THE OAK RIDGE MEADOWS APPLICATION
SHADDEN IS THE ACCESS STREET THAT THE OAK RIDGE MEADOWS APPLICATION SUPPORTS

Exhibit 26

Our suggestion for proposed street names

PREMIER DEVELOPMENT OAK RIDGE MEADOWS SUBDIVISION EMERGENCY VEHICLE ACCESS PLAN		REVIEW REVIEW	VERIFY SCALE DRAWN BY: [] CHECKED BY: [] DATE: APR. 2010	NO. DATE REVISIONS
			JOB NUMBER 2335_4000.0	DRAWING C7.0

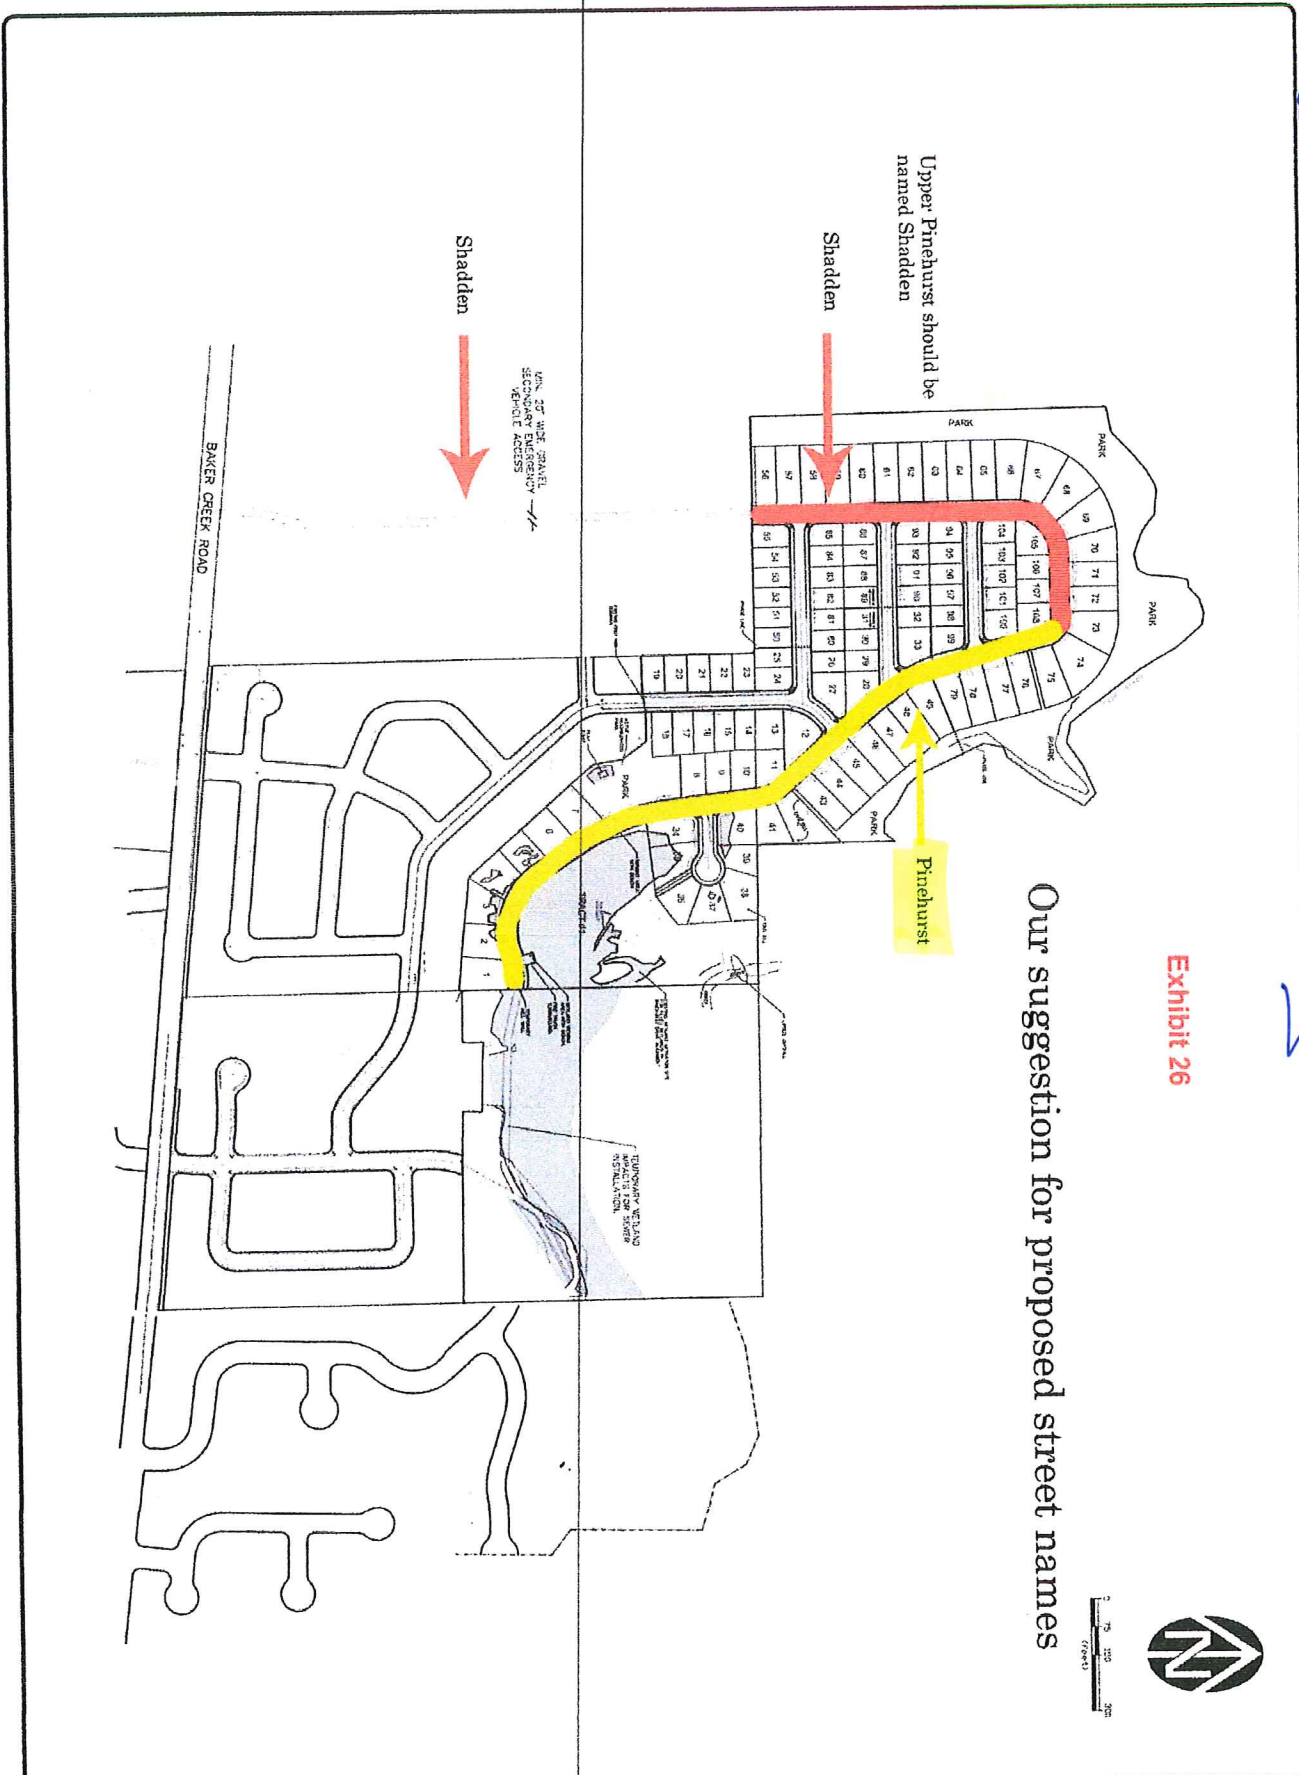
THE ACCESS ROAD TO THAT LOWER 4722 PROPERTY IS ONE OF THOSE ISSUES. -- WE DON'T THINK THAT SECTION OF ROAD MEETS A SINGLE COMP PLAN GOAL OR POLICY. --- BUT THE APPLICATION CLAIMS "PINEHURST STREET" MEETS AT LEAST 15. ----- IT TOOK ME A WEEK TO REALIZE THAT IS BECAUSE --- PINEHURST STREET RUNS IN TWO TOTALLY DIFFERENT DIRECTIONS!! --- SO, LIKE THE PROPERTY --IF YOU SEPARATE THE ROAD INTO:

- AND UPPER ROAD THAT RUNS N/S. AND;
- A LOWER SECTION ---- THAT RUNS MOSTLY E/W.

YOU WILL REALIZE THAT --- THE PRINTED NARRATIVE OF THE OAK RIDGE MEADOWS APPLICATION --- IS REALLY SUPPORTING THE SHORTER UPPER SECTION OF N/S ROAD. -- THAT SECTION RUNS STRAIGHT TO AN INTERSECTION OF BAKER CREEK ROAD AND SHADDEN -- ON THE SOUTH SIDE OF BAKER CREEK ROAD.

FOR THAT REASON -- I BELIEVE THAT THE SECTION OF ROAD THAT BEST SERVES APPROXIMATELY 90% OF THE HOMES IN THE OAK RIDGE MEADOWS DEVELOPMENT -- SHOULD BE NAMED AS THE PRIMARY ACCESS ROAD TO THE OAK RIDGE MEADOWS DEVELOPMENT. ---- AND THAT IS THE ROAD THAT RUNS N/S -- AND WILL EVENTUALLY CONNECT TO SHADDEN STREET.

- IN THE AREA OF "ACCESS" – IT IS OBVIOUS THAT SHADDEN STREET WILL PROVIDE A FAR SUPERIOR ACCESS STREET TO 90% OF THE FUTURE RESIDENTS OF OAK RIDGE MEADOWS THAN PINEHURST STREET.
- A SHADDEN STREET ACCESS – ALSO AVOIDS ALL OF THE ENVIRONMENTAL AND LIABILITY ISSUES INVOLVED WITH THE LOWER SECTION OF ROAD.

Please detach - And then Mattett Police codes to each Road when Reading
